ELECTRONICS FIELD CHANGE BULLETIN
 NAVAL SHIP ENGINEERING CENTER, NAVY DEPARTMENT
 WASHINGTON, D. C.

23-AN/URC-32
 9-AN/URC-32A
 14-KWT-6(8)

MODIFICATION OF FREQUENCY GENERATOR CV-731/URC
 TO ACCEPT FREQUENCY CONVERTER CV-1749()/UR

PURPOSE: To modify the Frequency Generator CV-731/URC to accept the Frequency Converter CV-1749/UR. This will permit the Radio Set AN/URC-32() to be tuned in .1 KC increments.

FIGURE 1

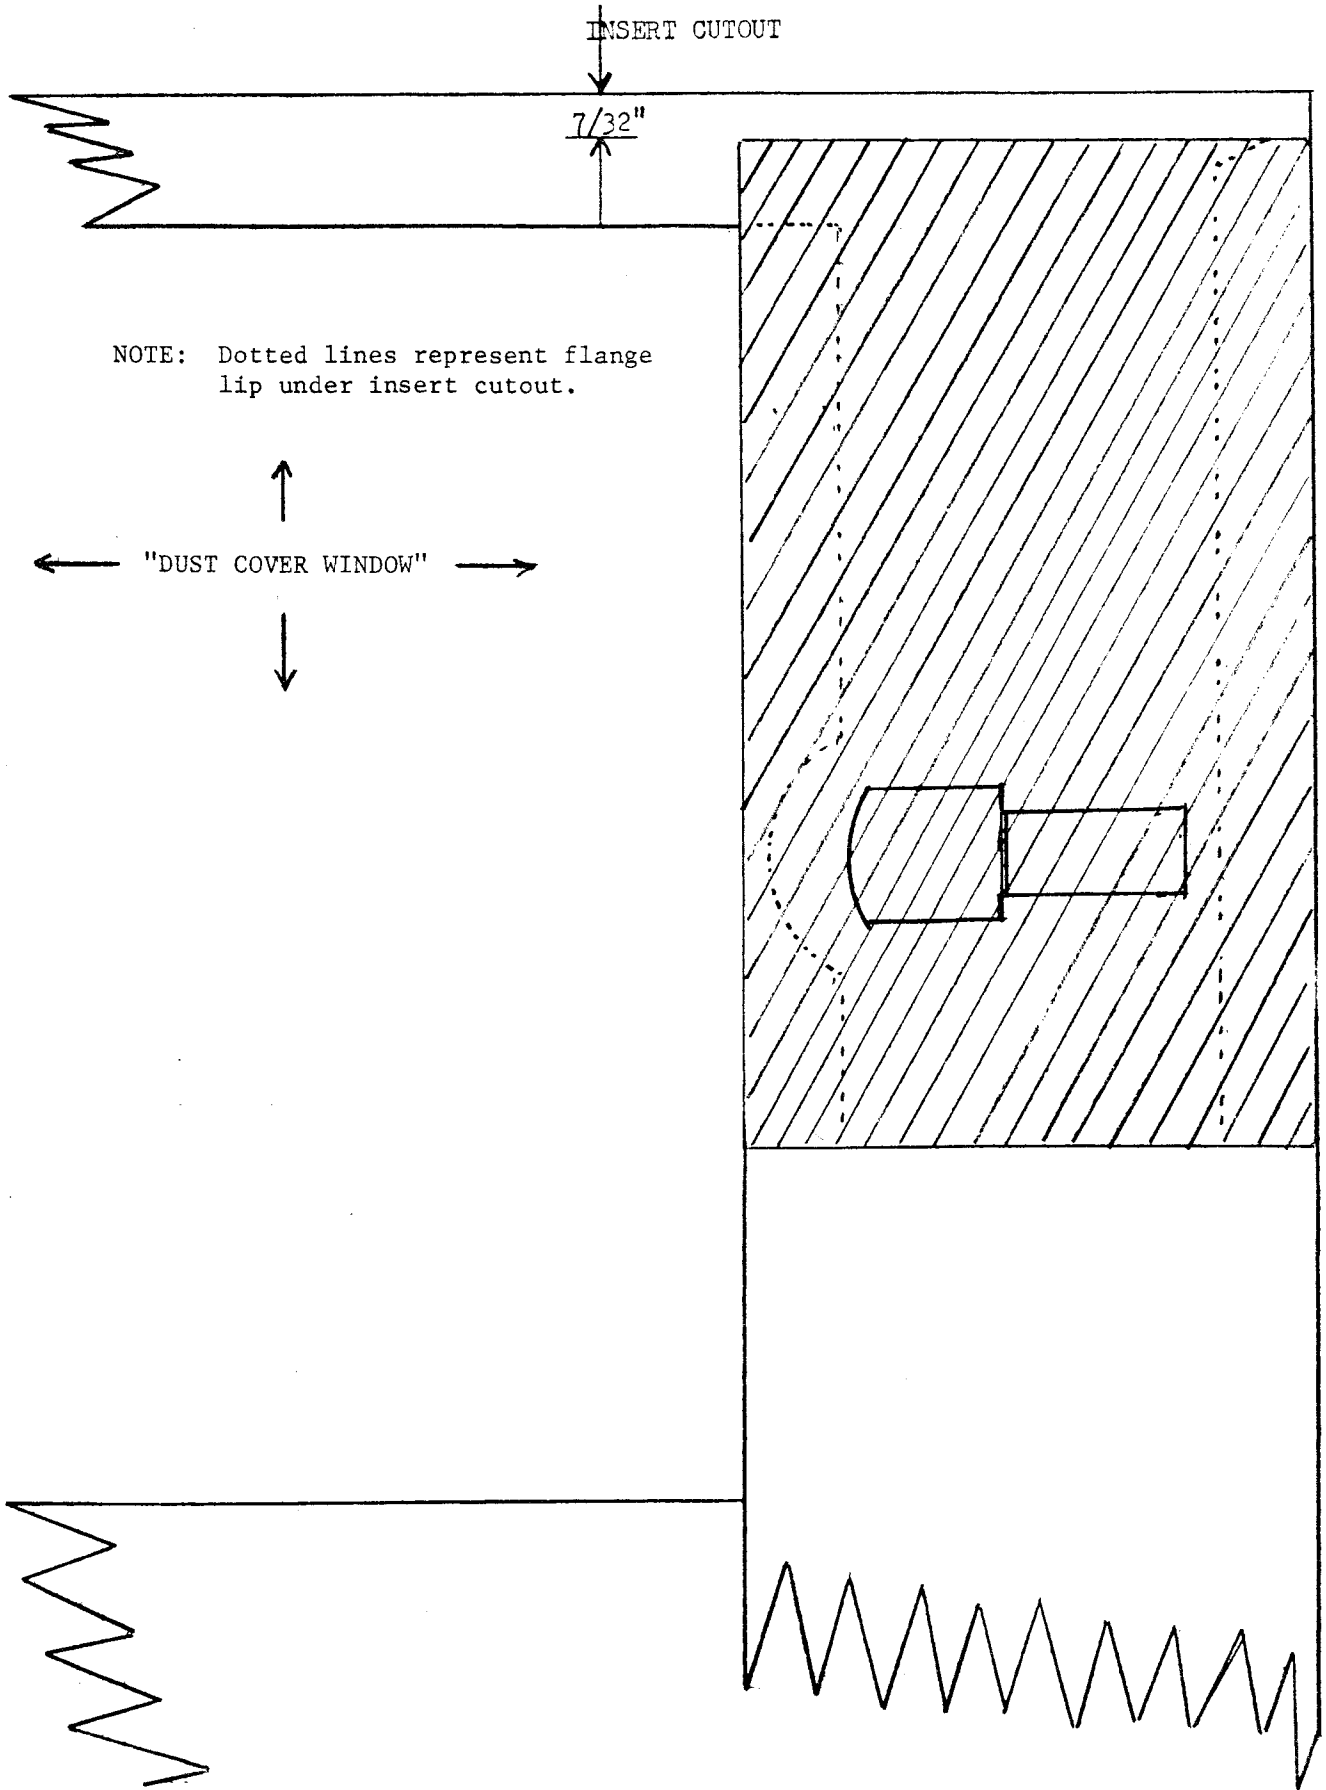
34. Place the dust cover on the work bench.
35. Refer to Figure 1. Use the combination square and scribe a line 7/32" down from the top of the right hand corner of the dust cover.
36. Place Item 5 face down on the dust cover. Use the 7/32" line scribed in Step 35 to locate the top edge of Item 5. Line up the side edges of the insert (Item 5) and scribe another line across the dust cover at the bottom of the insert (Item 5). At the right hand corner of the dust cover window, scribe a short line at the left top corner of the insert up to the 7/32" line.

37. Lay the insert (Item 5) aside and cut out the layer of metal as indicated by the diagonal lines in Figure 1. CAUTION: DO NOT CUT THE FLANGE LIPS UNDER THE CUTOUT. MAKE CUTS INSIDE THE SCRIBED LINES.

38. Break the spot welds or rivets securing the cutout to the flange lips and remove the cutout. CAUTION: DO NOT TEAR THE FLANGE LIPS.

39. Hammer the bends and bumps out of the flange lips.

FIGURE 2
FLANGE CUTOUT

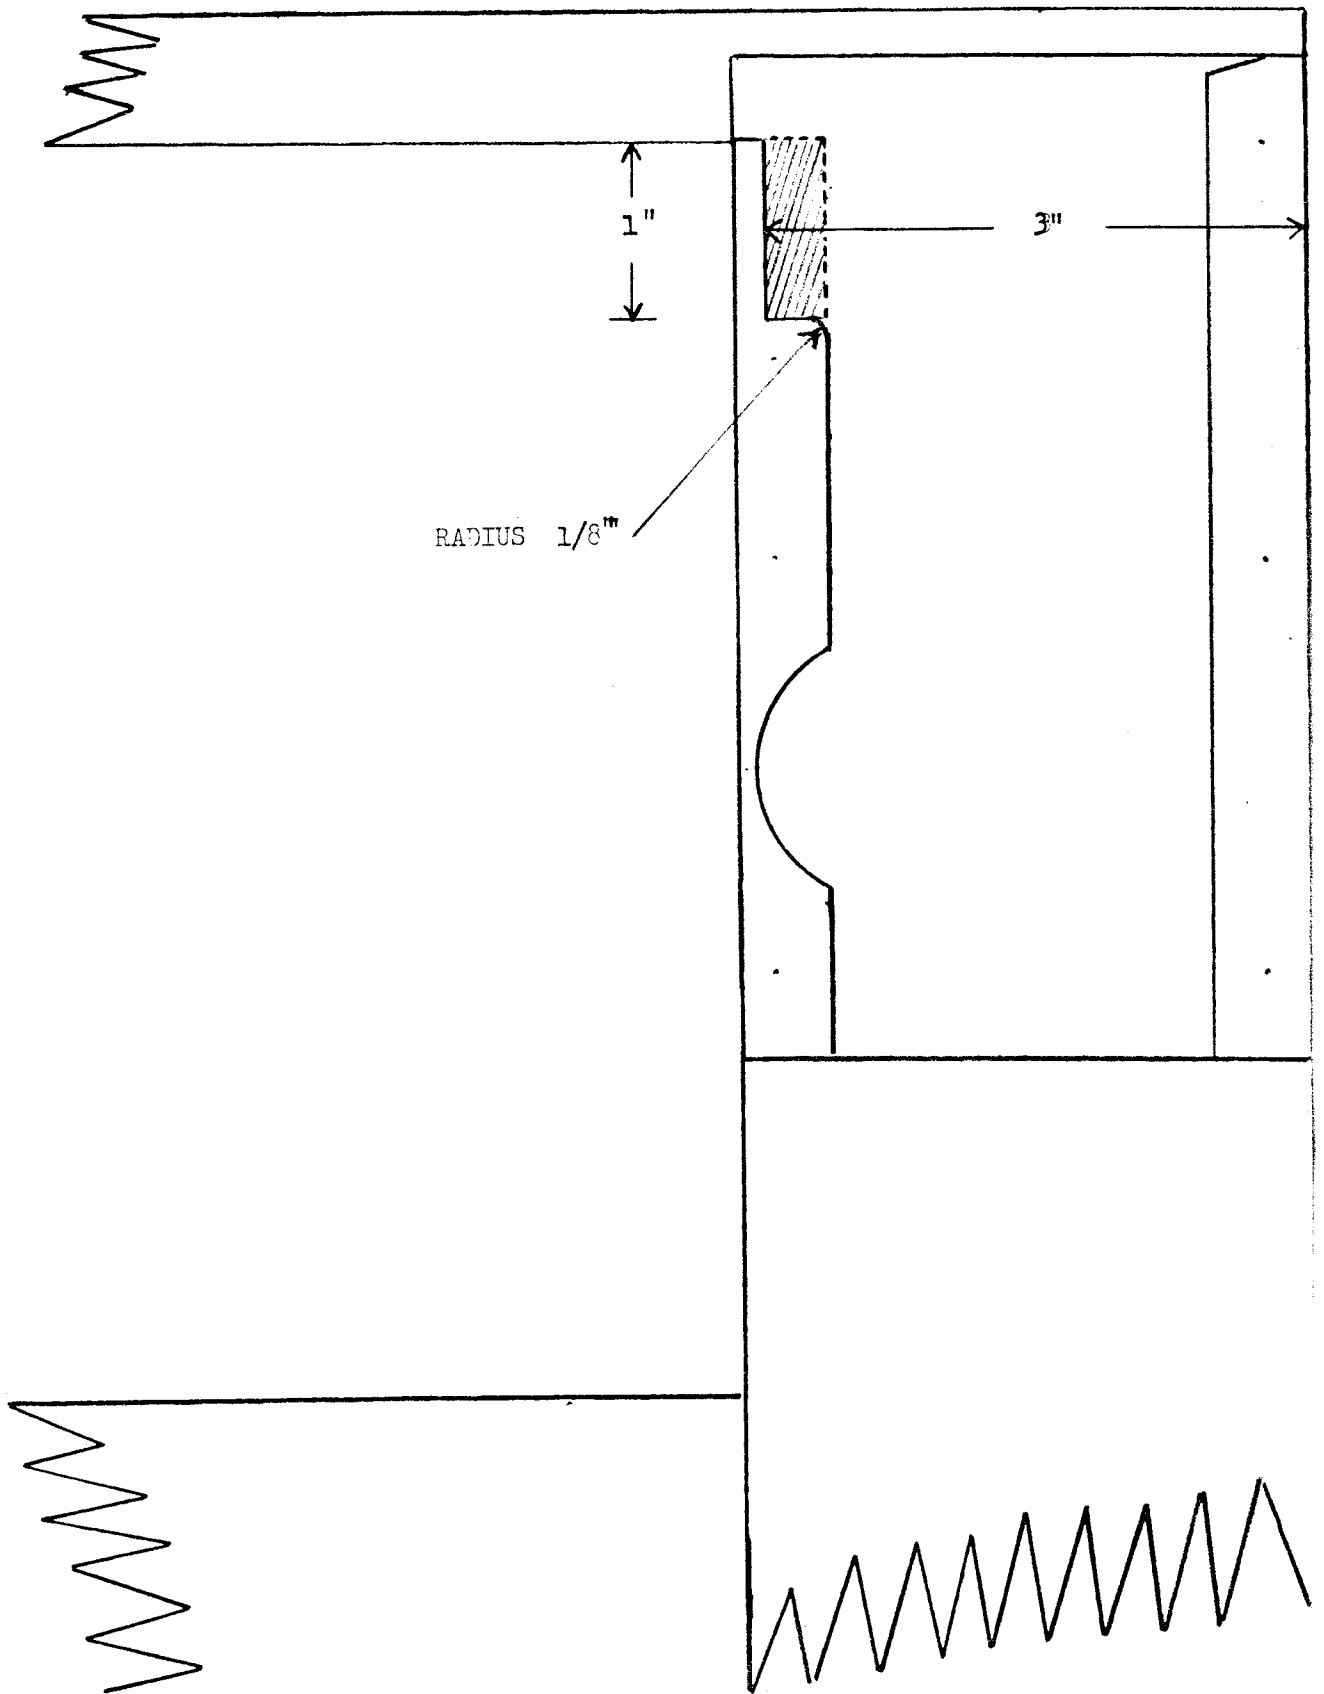
40. Make the cutout at the top of the exposed flange lip as indicated by the measurements and diagonal lines of Figure 2.

43. With the insert (Item 5) in place as shown in Figure 3 (CAUTION: THE SNAP FASTENER IS LOCATED AT THE TOP OF THE INSERT, FIGURE 3), drill the mounting holes with the #37 drill and secure the insert (Item 5) to the dust cover flanges with the rivets furnished in Item 1.

FIGURE 5
HOLE PATTERN TEMPLATE

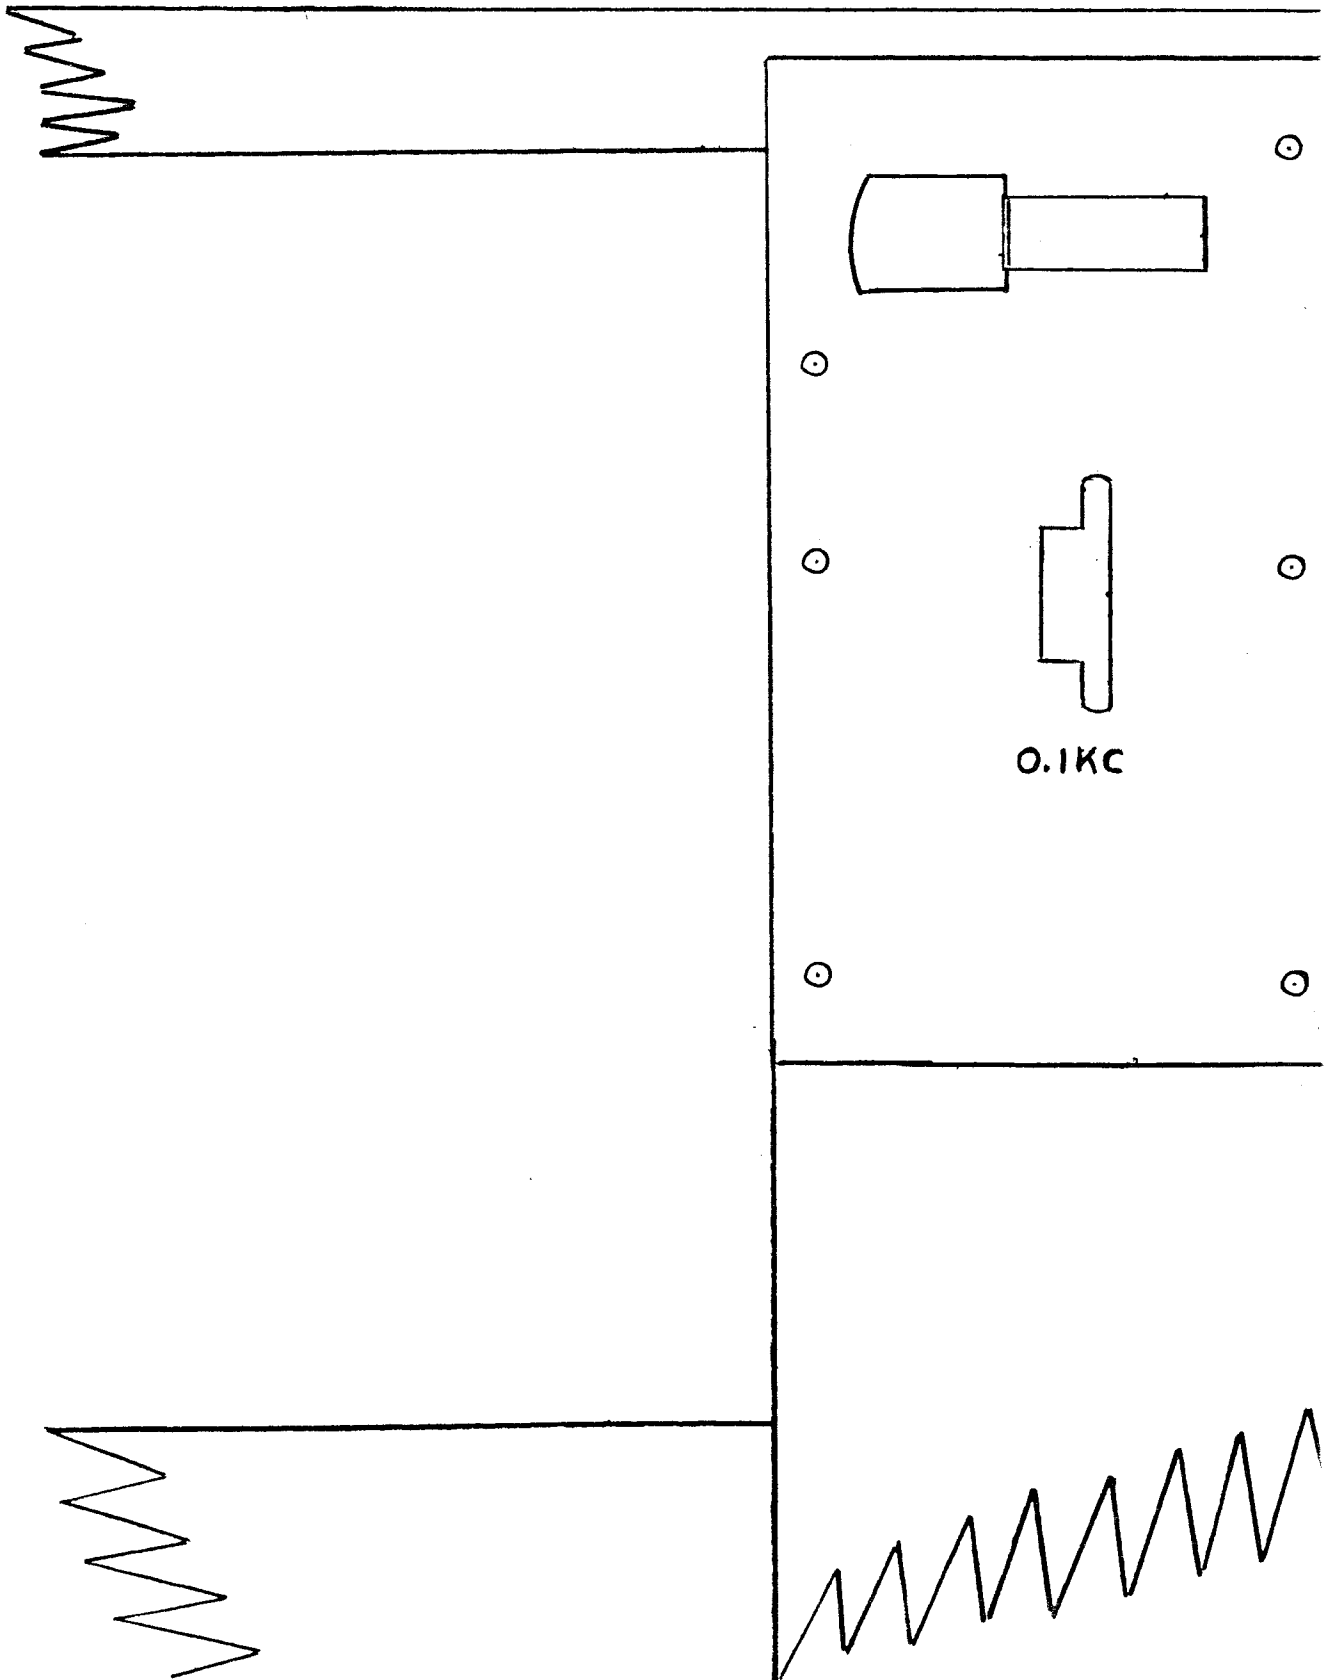
9. Refer to Figure 5. Place the template (Item 2) on the front side of the chassis so that holes "A" of the template as indicated in Figure 5 line up with the retaining screw holes for the frequency divider module.

10. Secure the template (Item 2) to the chassis, using the two 8-32 X 3/8" binder head screws (Item 6).
11. Center punch the two "B" and the two "C" holes as indicated in Figure 5. Use a #8 drill and drill the four holes.

12. Countersink the two "C" holes on the rear of the main chassis plate so that the heads of the two 8-32 flat head screws (Item 6) will be flush with the chassis.

13. Cut out rectangular hole "D" as indicated in Figure 5.

1. Secure template, item 2, using threaded retaining holes for Frequency Divider and holes A of Template
2. Drill B and C holes, using a #8 drill, in main chassis of Frequency Generator.
3. Countersink C holes from rear of chassis so that E-32 flathead screws are flush with chassis.
4. Cutout rectangular hole D.
5. J₄ is Frequency Divider jack.

FIGURE 4

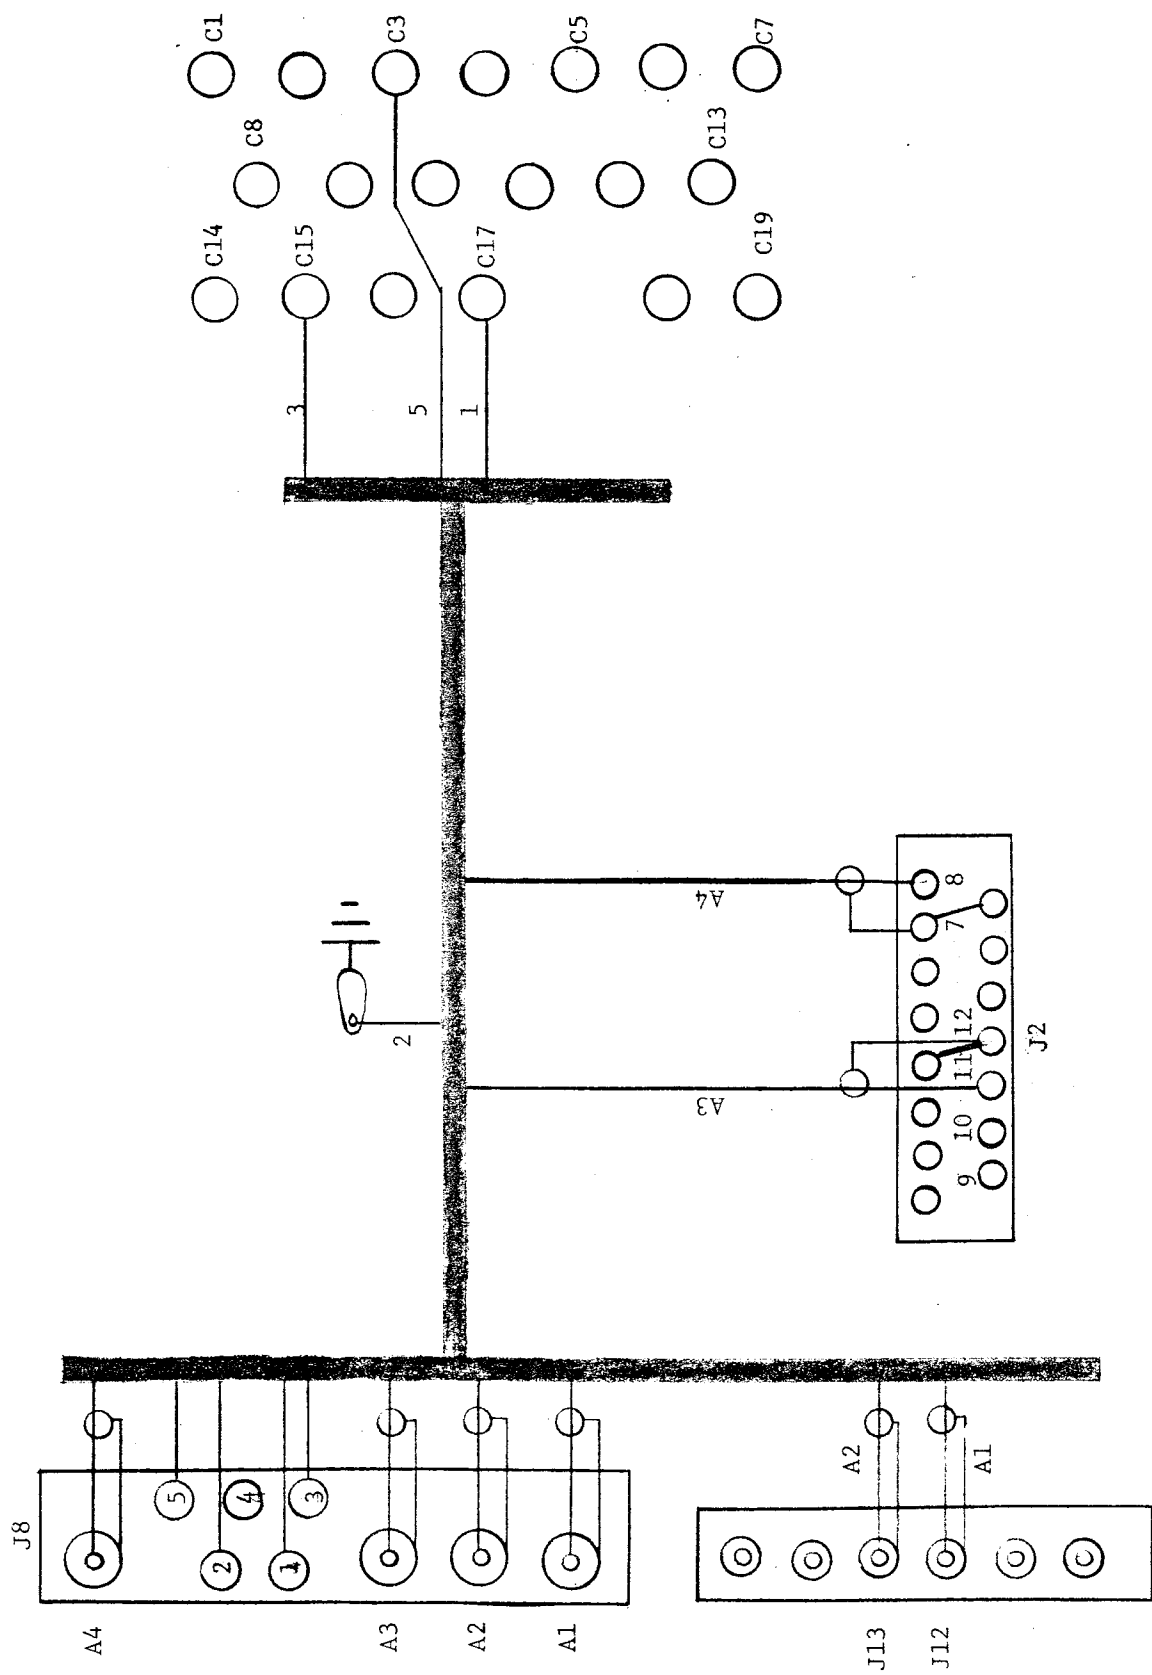
25. Refer to Figure 4 and route the leads attached to the mounting base, jack (J8) of Item 4 as follows:

From jack J8:	Lead Color:	To:
Terminal A1	White Coax	J12 (shield to J12 ground terminal)
Terminal A2	White Coax	J13 (shield to J13 ground terminal)

Terminal A3	White Coax	Center Conductor to J2-11. Shield to J2-12 ground jumper
Terminal A4	White Coax	Center Conductor to J2-8. Shield to J2-7 ground jumper
Terminal 1	Wh-Blue-Blk	C17
Terminal 2	White	Ground Lug
Terminal 3	Wh-Red-Blue	C15
Terminal 5	Wh-Red-Grn-Blk	C3

Determine lead lengths to coincide with the existing leads which made up the original cable harness. Make the soldered connections as listed above and relace the added leads with the original leads to reform the cable harness.
